Service Bulletin

Bulletin No: JC-19-03

Product Type: BOB-CAT Zero Turn mowers

Customer Issue: Battery drains quickly or unable to start mower

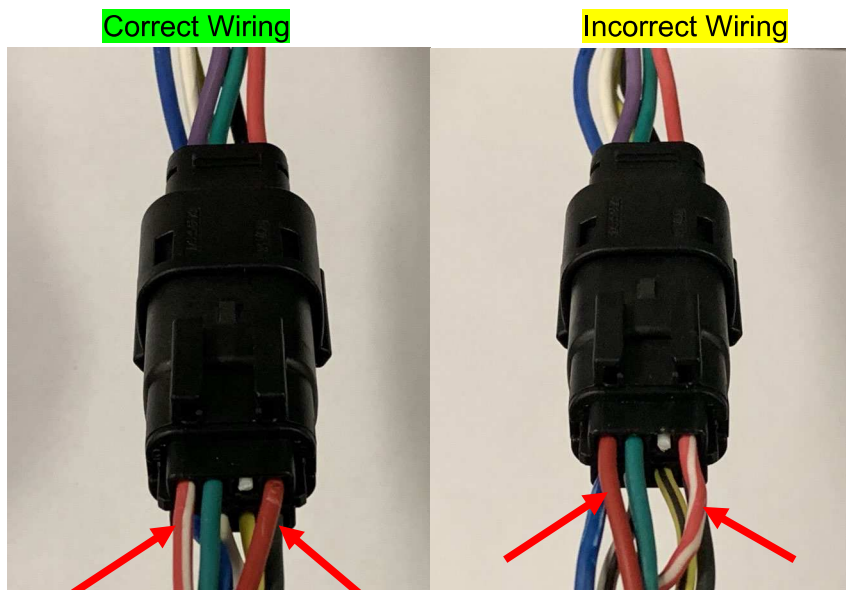
1. During setup at the dealership, inspect the engine wiring harness connector for switched wires. This can be done one of two ways:
 - a. Hook up battery and see if the hour meter comes on when the key is in the Off position. If the hour meter displays any information with the key off, the wires noted are likely switched. This would apply to inspecting new units being uncrated.
 - b. Inspect the engine wire harness where it connects to the main harness (between the engine and seat). The red wire should be next to the blank receptacle and the red wire with white stripe should be next to the green wire. See below for correct wiring.

- c. If you find the wires are reversed, please replace the engine harness (P/N 4176255).
